SYSTEM "D" - INTERSECTION NOTES  
 TH 94 AT CSAH 19 (WOODBURY DR) S RAMP  
 IN WOODBURY, WASHINGTON COUNTY

SYSTEM "D" - FIELD WIRING DIAGRAM 1 OF 2  
 TH 94 AT CSAH 19 (WOODBURY DR) S RAMP  
 IN WOODBURY, WASHINGTON COUNTY

TRAFFIC SIGNAL SYSTEM 'D'  
 INTERSECTION LAYOUT  
 CSAH 19 (WOODBURY DR) AT I-94 SOUTH RAMPS

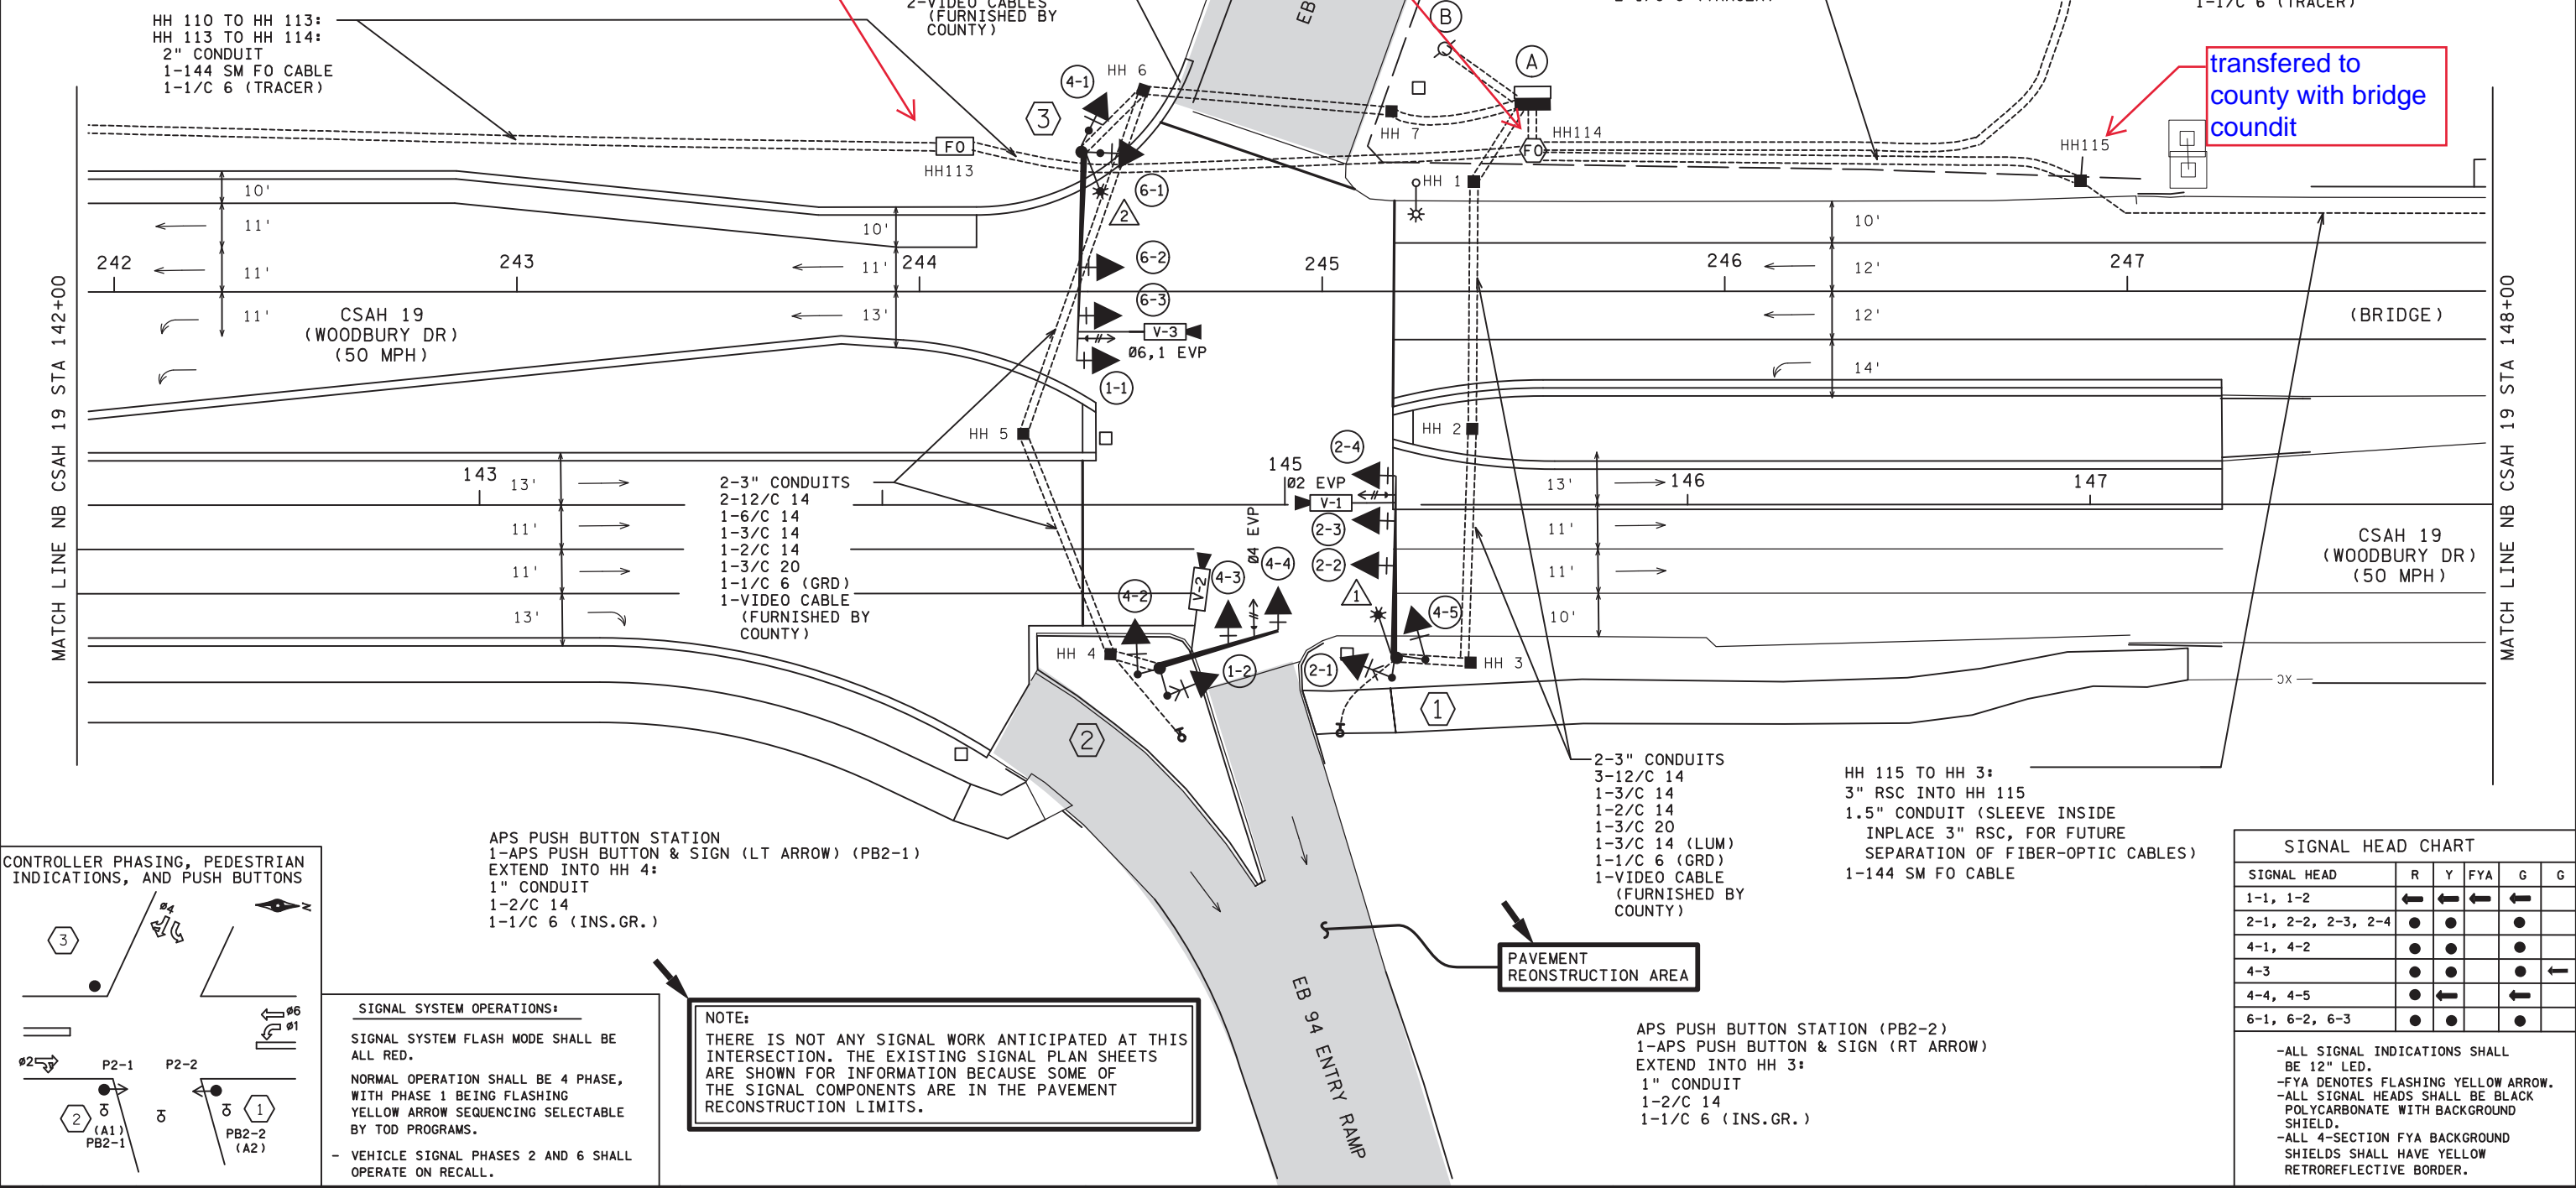
remove from plan sheets. Fiber owned by county and located by them

conduit from cabinet to HH114 exists but 12sm fiber has been removed. 6sm is still installed (through HH114) and coiled in the cabinet

future project to reroute this conduit directly into cabinet pad. currently in place as shown

transferred to county with bridge conduit

batteries and inverter removed  
 by county as they were not  
 covered in the agreement

removed by county

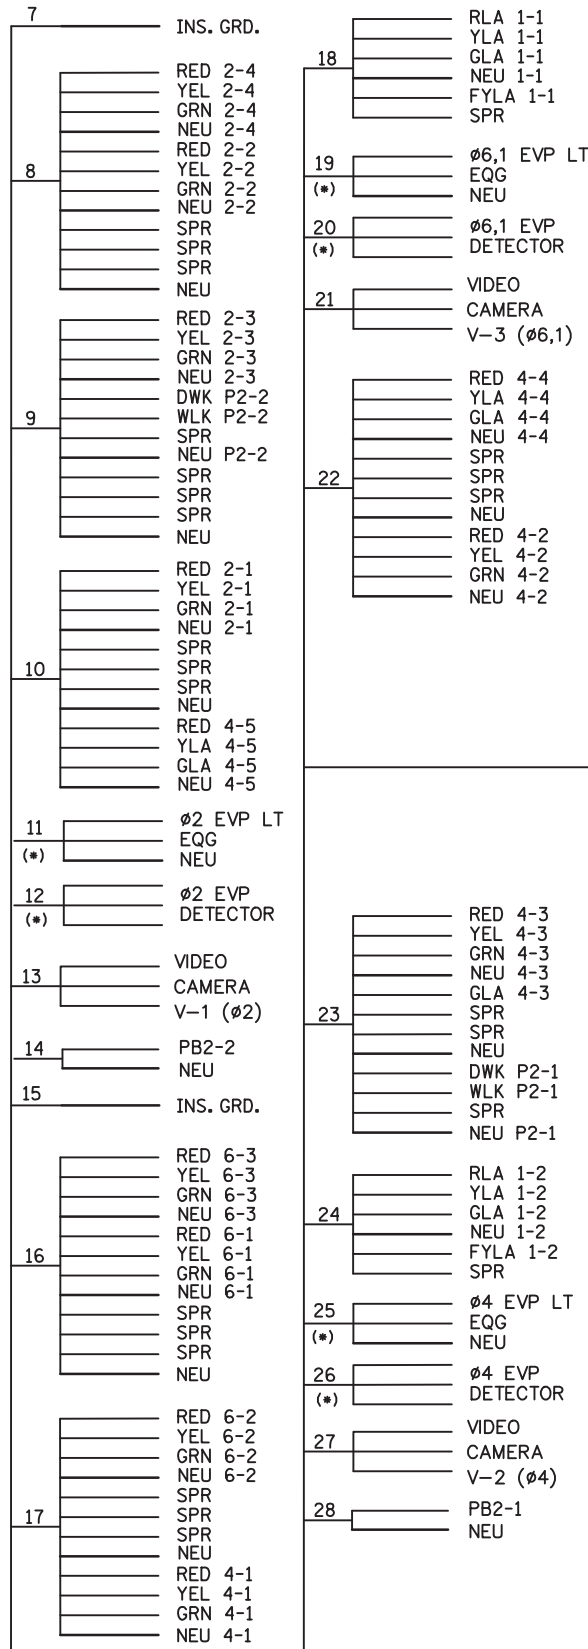
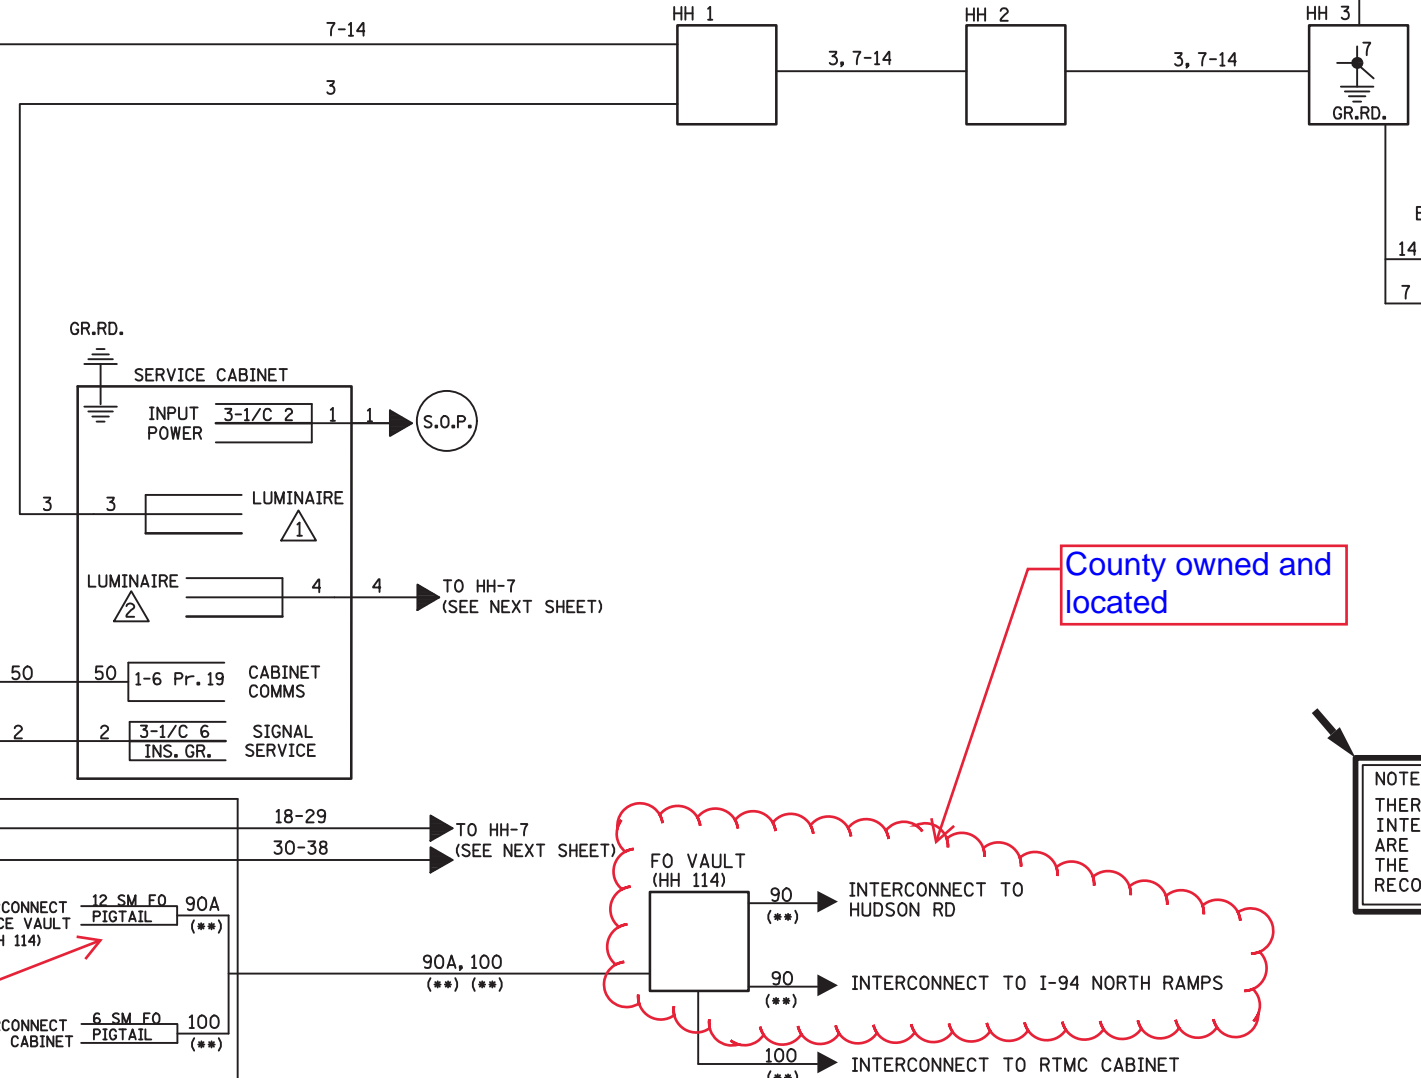
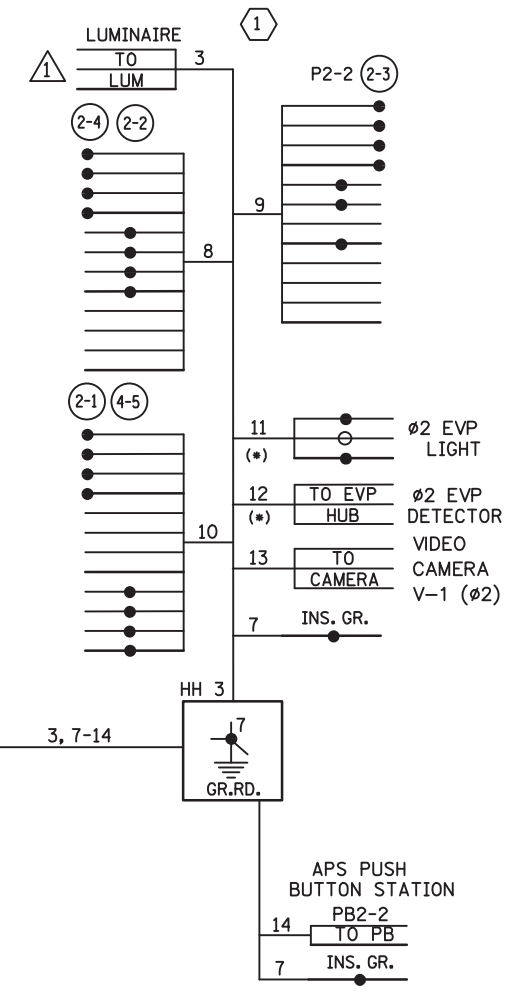
batteries and inverter removed by county as they were not covered in the agreement

County owned and located

removed by county

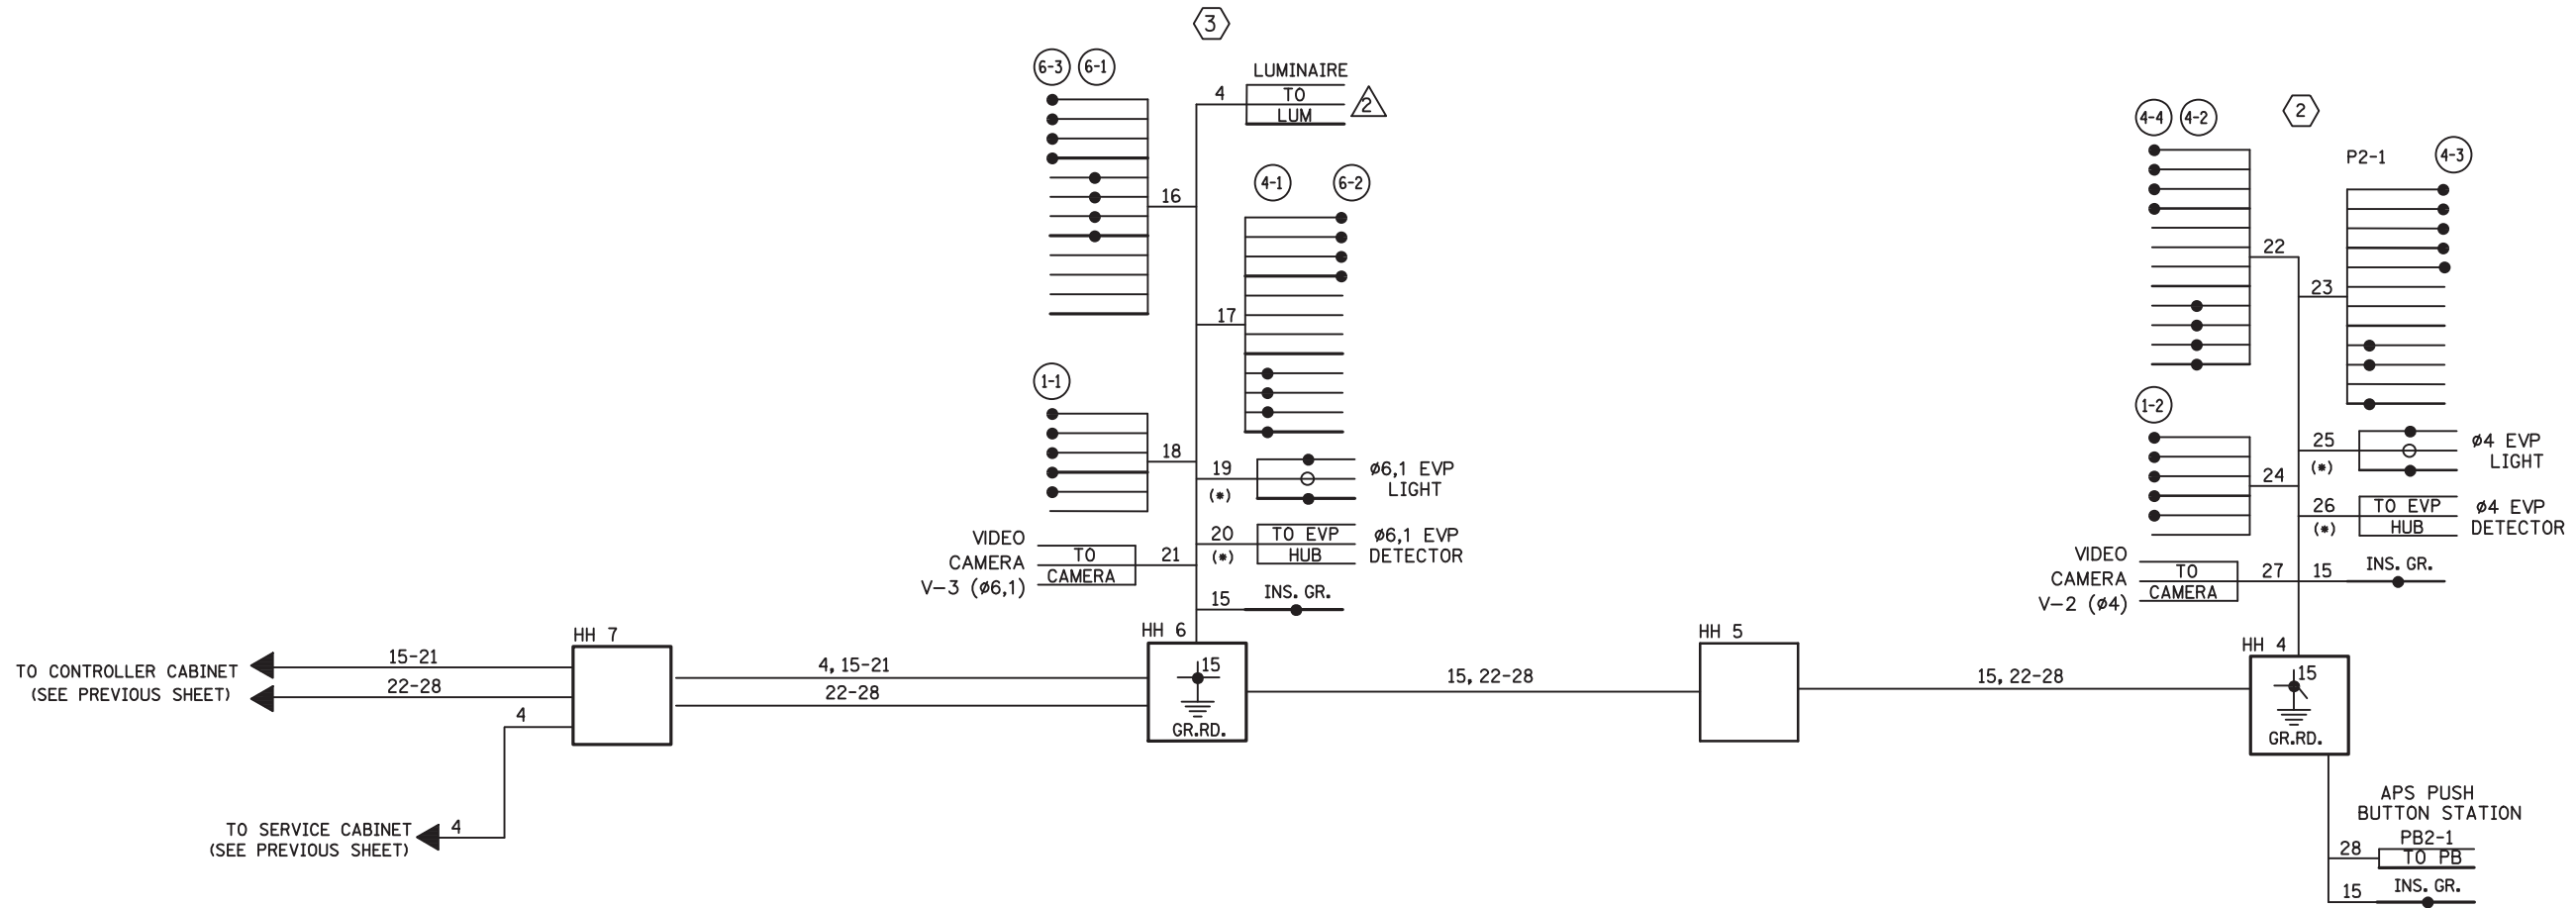
batteries and inverter removed by county as they were not covered in the agreement
